BOARD ACTION REPORT – APPEALABLE ITEM

| Project Name: | Subculture Coffee |
| Request: | Certificate of Appropriateness (COA) and Class III Site Plan Modification |

STAFF REPORT

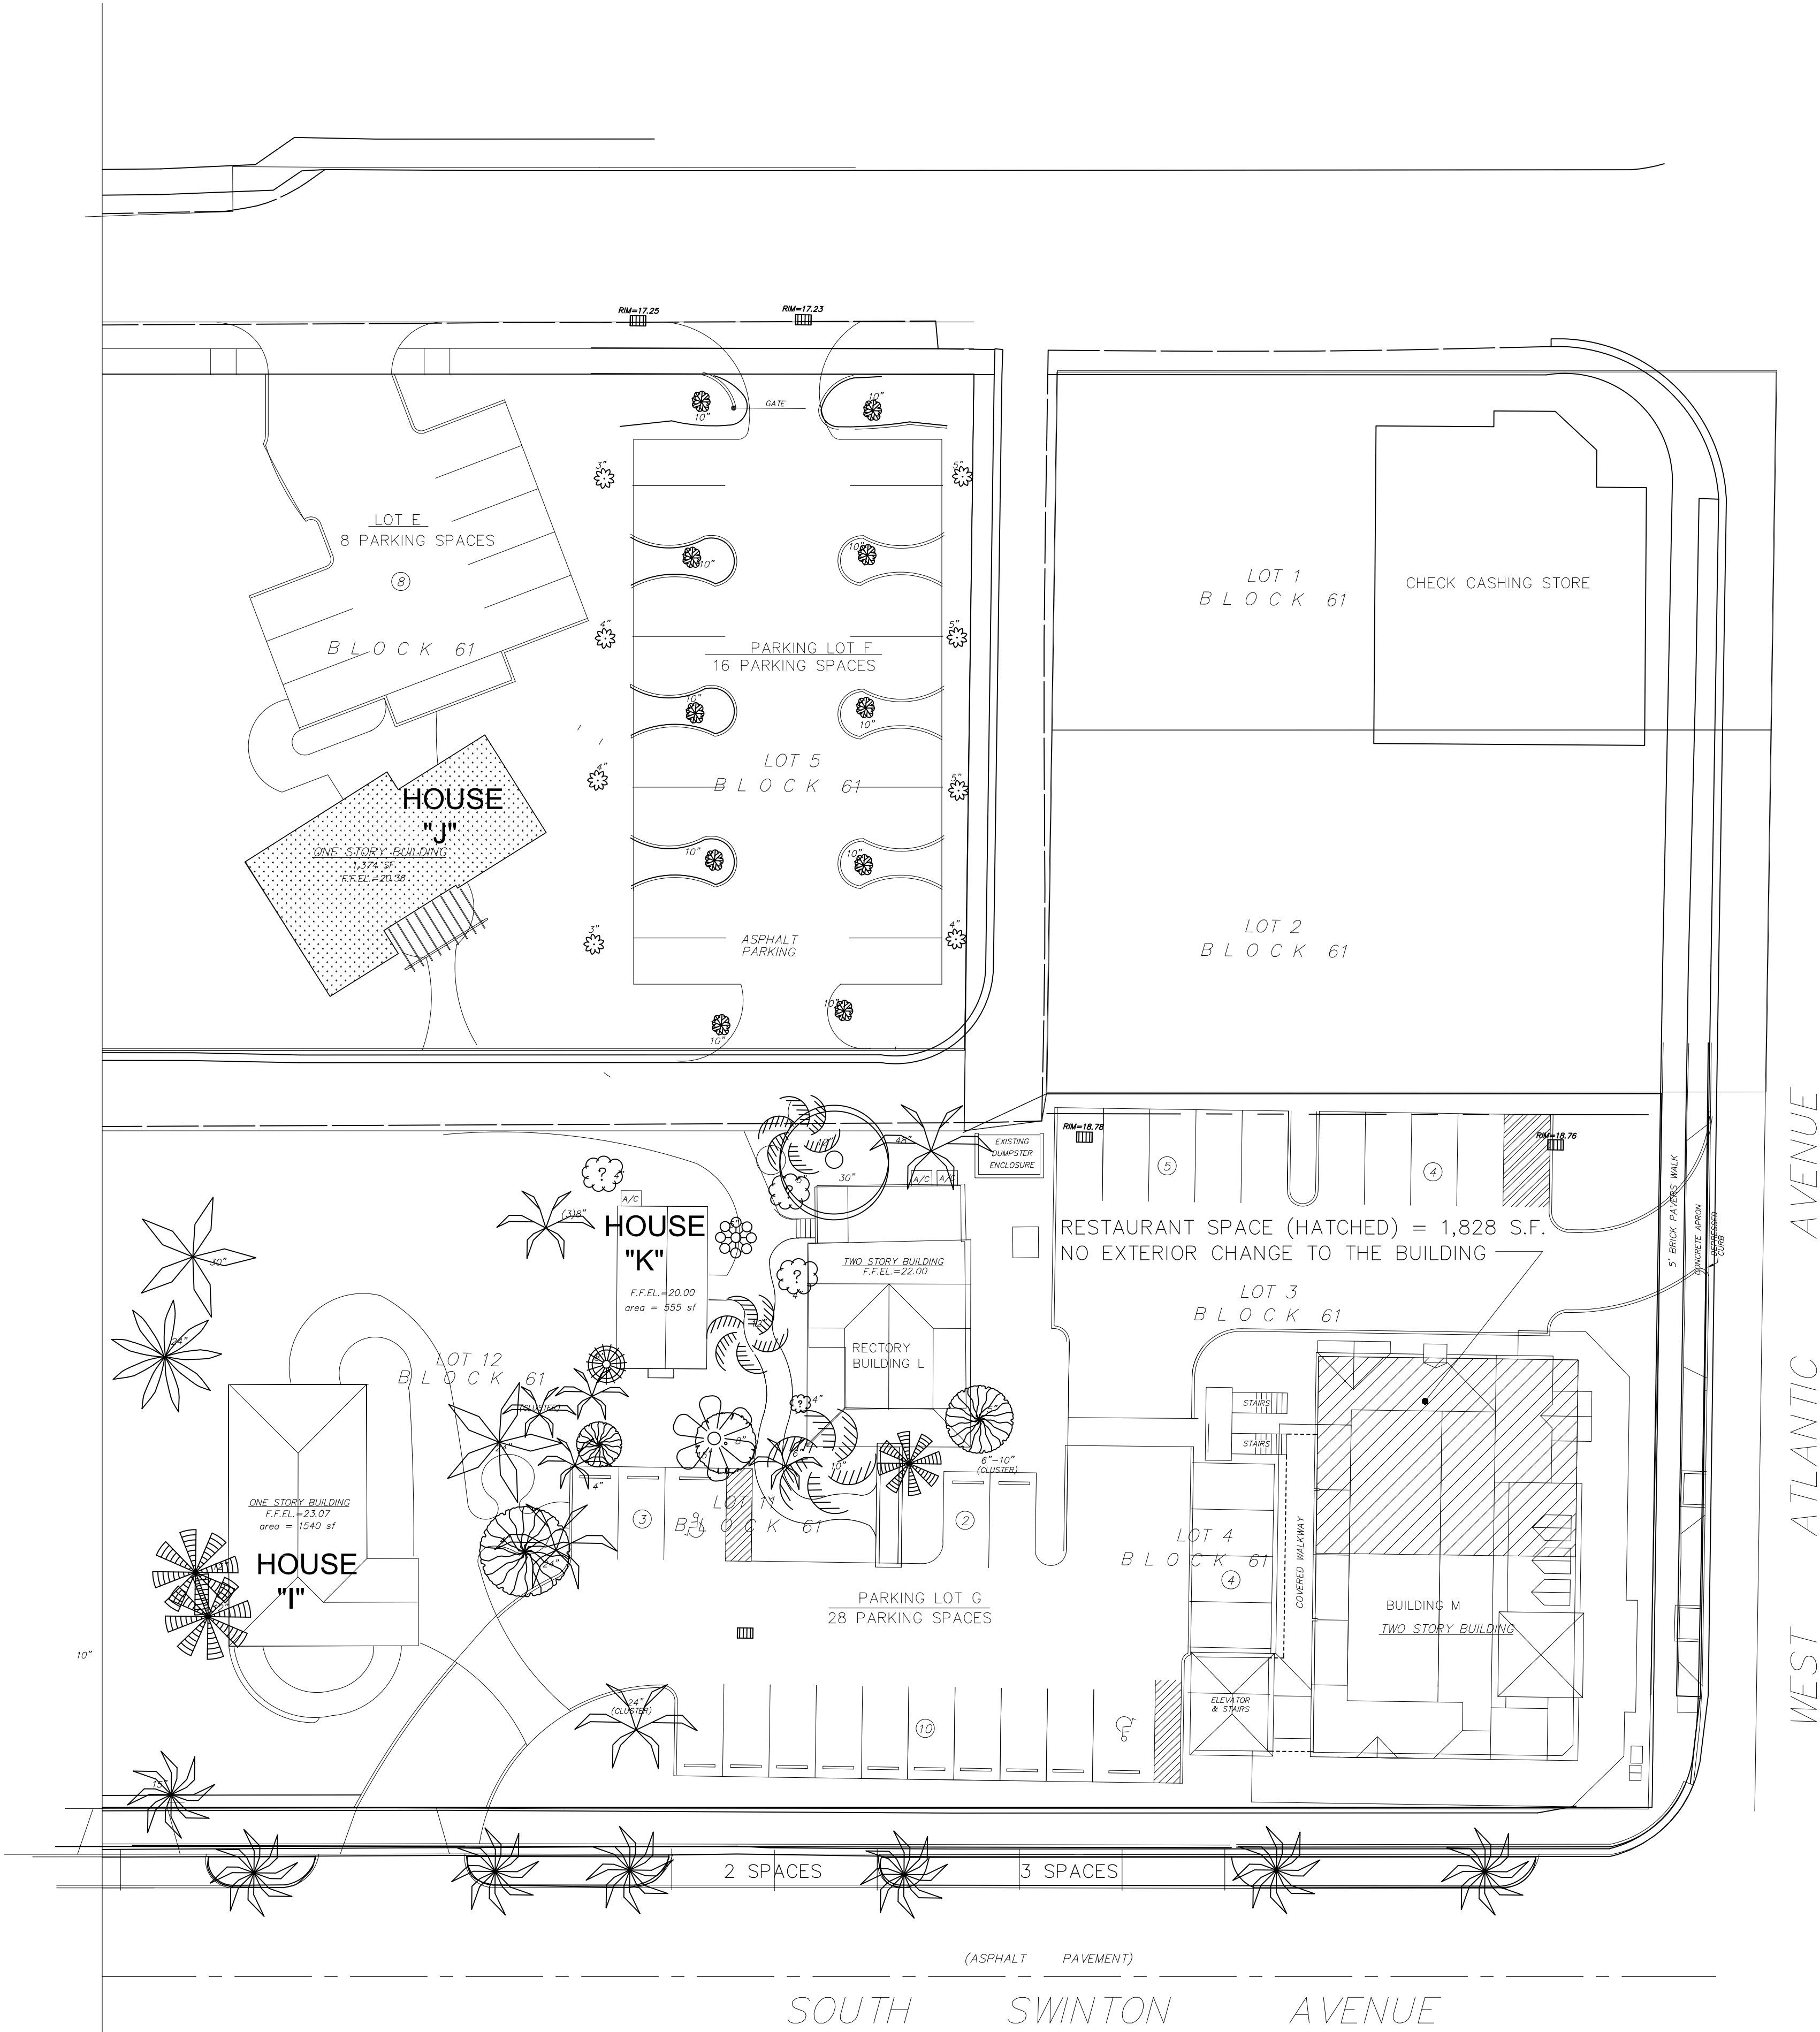
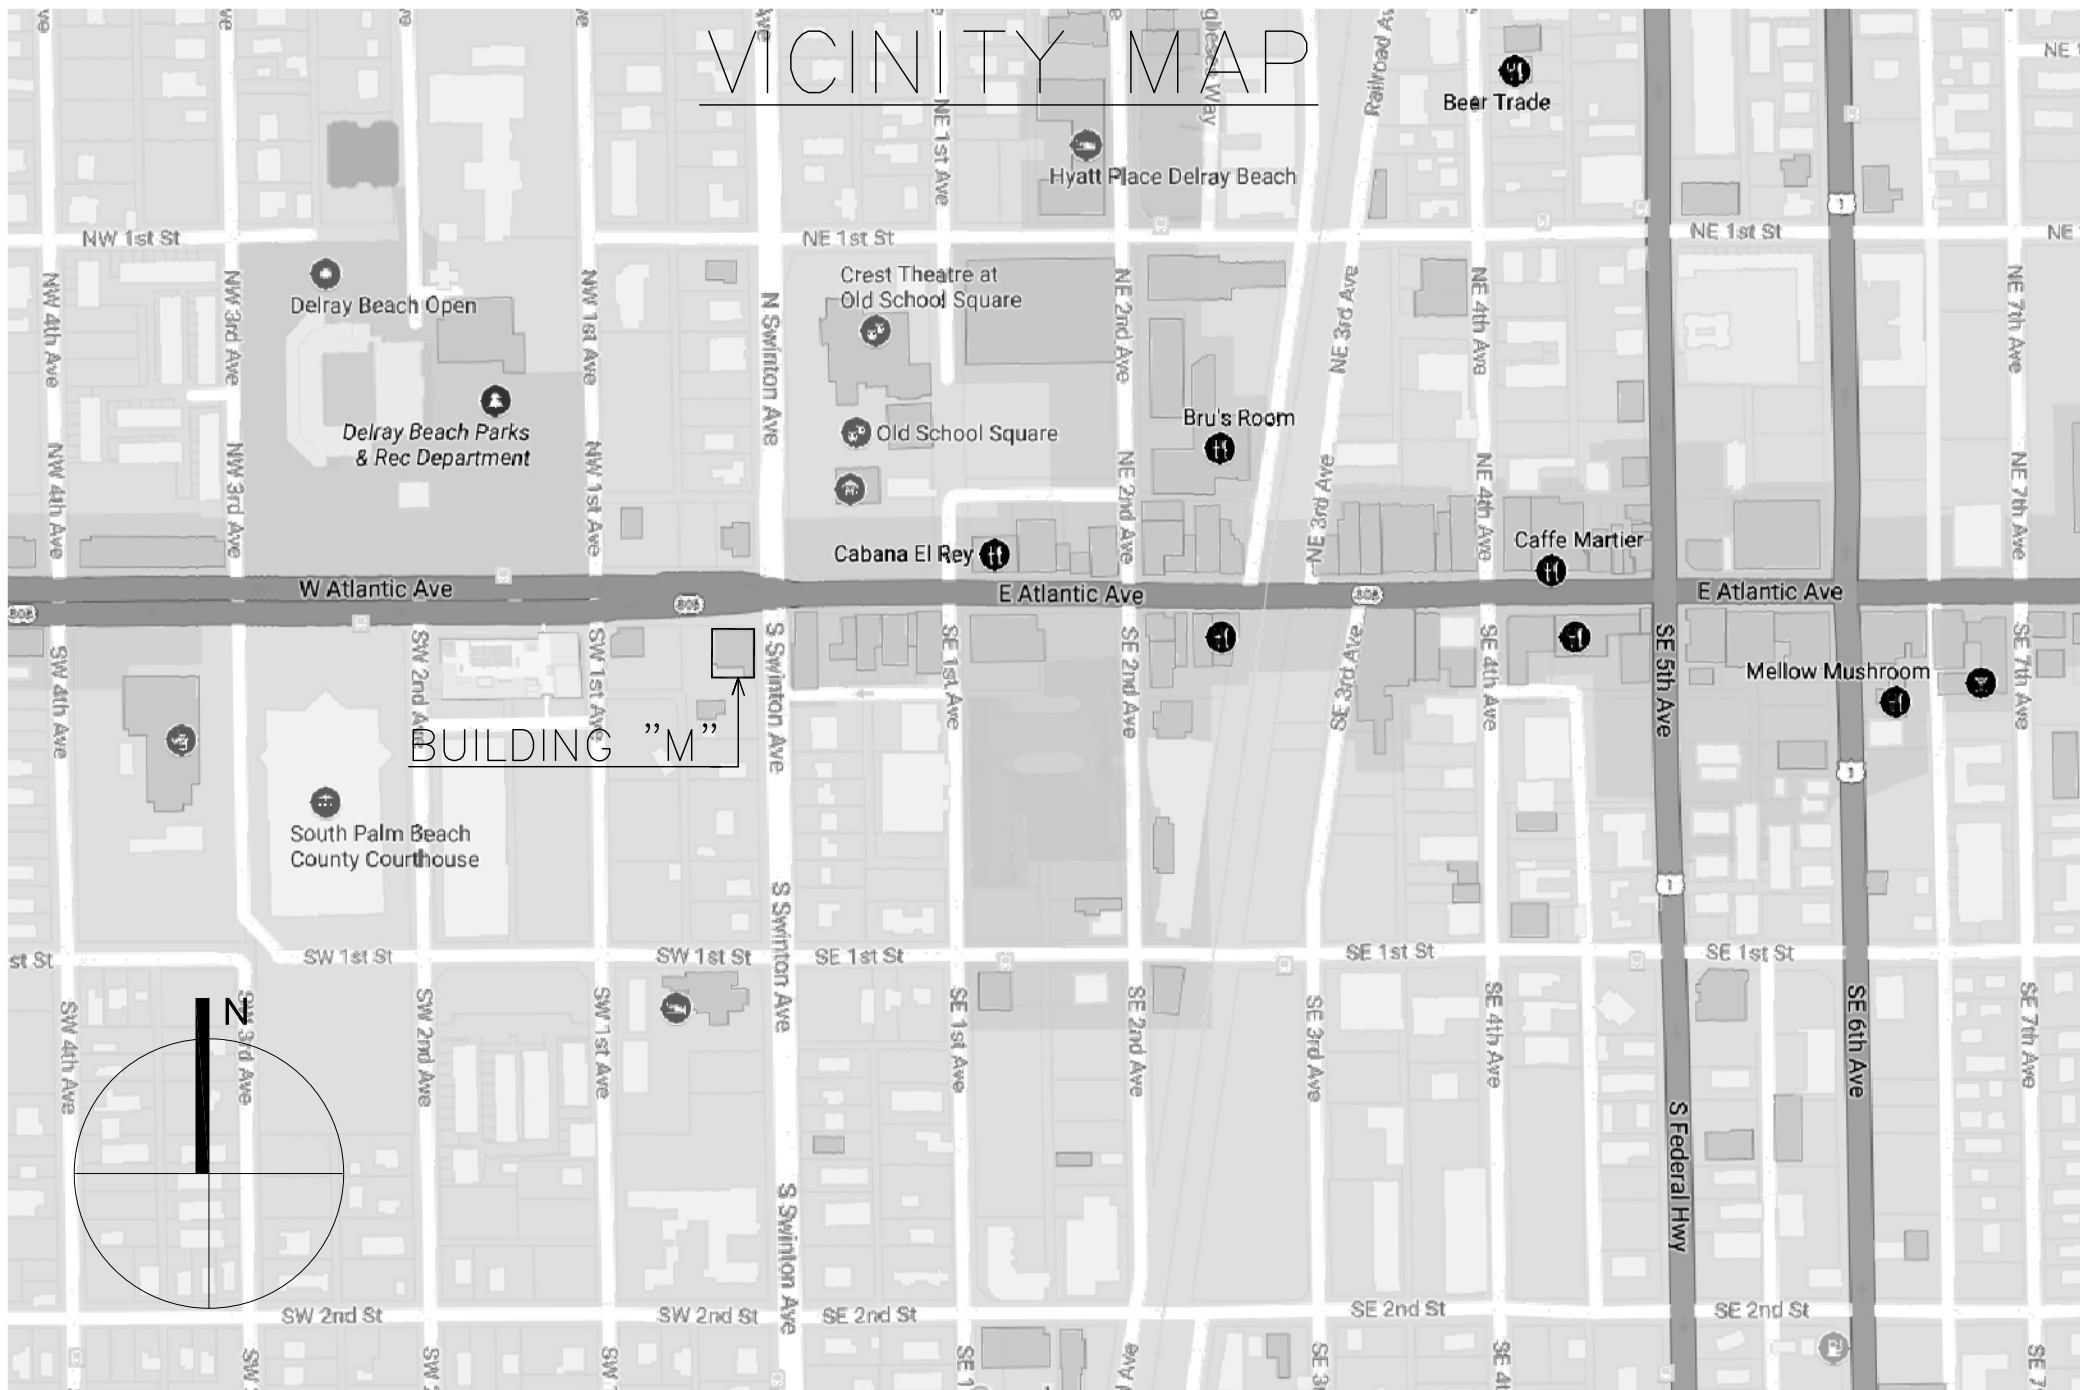
1. Adjust the parking calculation numbers to correctly indicate the number of required parking spaces to be 37 spaces rather than 35 as noted on the site plan (sheet SP-1).

1. That the site plan be amended to correctly indicate the number of required parking spaces to be 37 spaces rather than 35 spaces; and,
2. That the applicant provides a letter from Palm Beach County Traffic Engineering Division that indicates that Traffic Performance Standards have been met.
